ARKANSAS POWER & LIGHT COMPANY  
POST OFFICE BOX 551 LITTLE ROCK, ARKANSAS 72203 (501) 371-4000

SUBJECT: Arkansas Nuclear One - Units 1 & 2  
Docket No. 50-313 & 50-368  
License No. DPR-51 & NPF-6  
Request for Additional Information  
to Appendix R Compliance Submittal

DRAWING NO.	REV.
1 INTAKE - 3

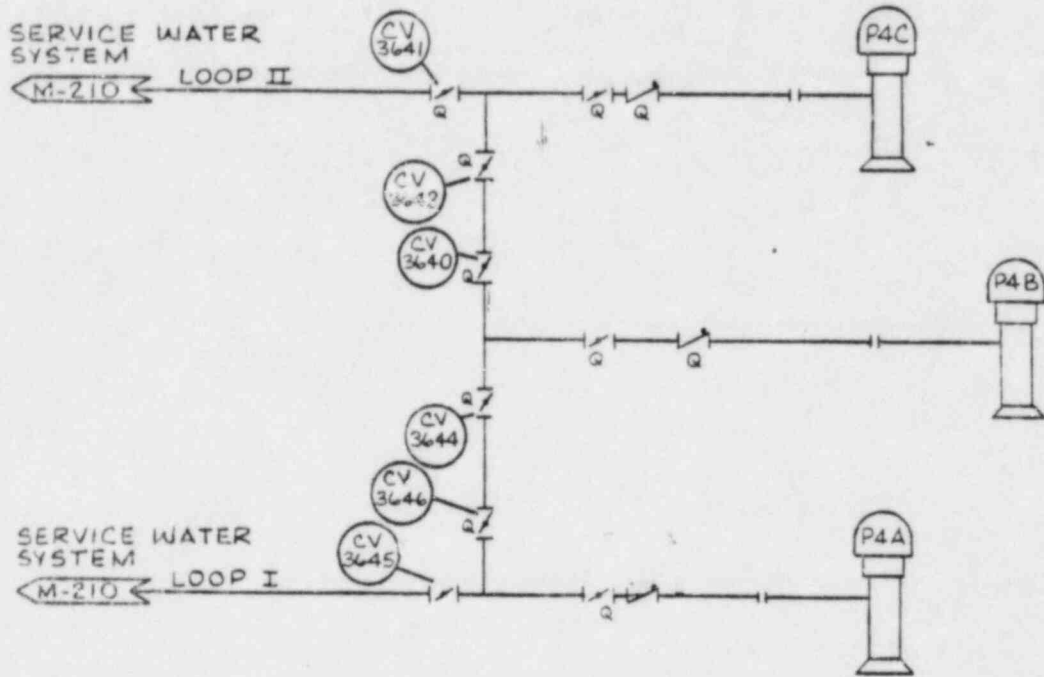
At elevation 354', a 1-hour barrier will be provided for the conduit and trays providing power for one of the two sets of three valves constituting one complete path from the swing pump (see Figure 1, INTAKE-3). As stated in our July submittal, power cabling for the pumps will be rerouted. Our exemption request for this elevation now is:

At elevation 354', the pump power cabling will be separated by greater than 20' but a suppression/detection system will not be provided.

At elevation 351', cabling for the crossover valves will be separated by less than 20' (but greater than 16'), a 1-hour barrier will be provided as stated above, but a suppression/detection system will not be provided.

REV.	DATE	REVISION	BY	CH'K	ENG'R	SUPVR
ARKANSAS POWER AND LIGHT COMPANY ARKANSAS NUCLEAR ONE UNIT II			 SCALE : DRAWN : K.W. DESIGN :			
			DRAWING NO.		REV.	
			2 INTAKE - 3

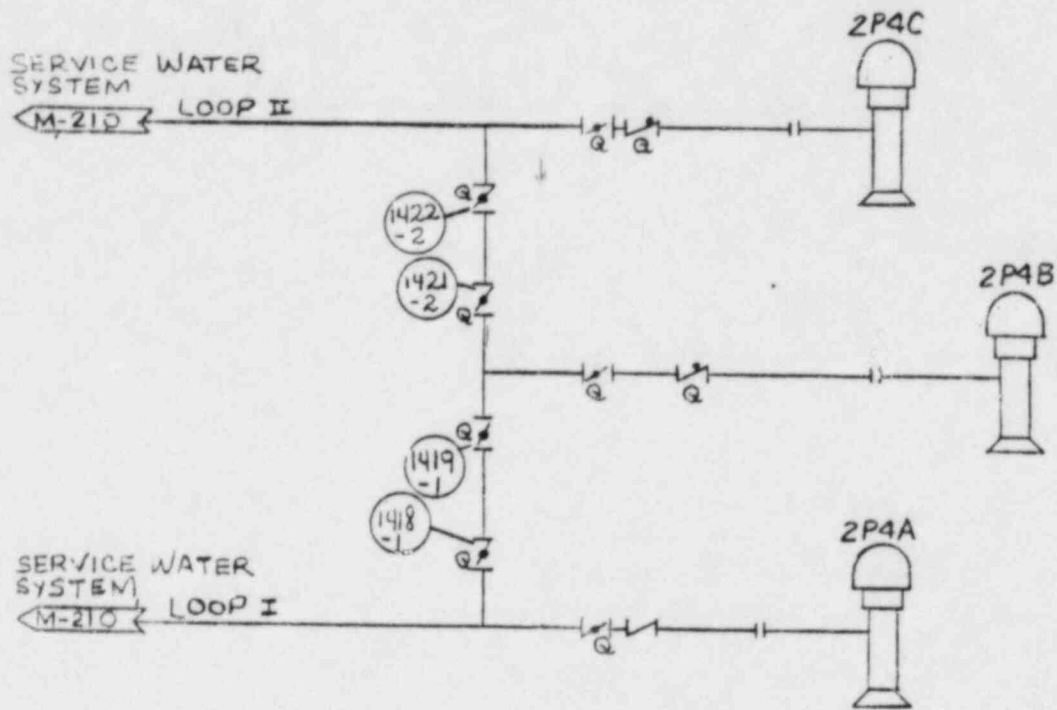
In clarification to the information provided in our July submittal, at elevation 366', separation of all four crossover valves (2CV1422-2, 1421-2, 1419-1 and 1418-1) is not necessary since loss of all four valves will not cause loss of service water (see Figure 2, INTAKE-3). Furthermore, these valves are separated from the three service water pumps by a full height concrete wall (see Figure 2, INTAKE-1). It is improbable that a fire on the valve side of the wall would spread to the pump side and destroy all three pumps. Nevertheless, an automatic suppression system will be provided to protect the three service water pumps. At this elevation our exemption request is now:

Omission of a 1-hour fire barrier, or omission 20' separation, for the service water pump motors when a sprinkler system and partial shielding is provided.

At elevation 354', one train of pump power cabling will be protected by a 1-hour barrier. As stated in our July submittal, these cables will be rerouted to provide at least 20' separation. Therefore, our exemption request for elevation 354' is now:

Omission of a sprinkler system where redundant safe shutdown cables are separated by greater than 20' and a 1-hour barrier is provided.
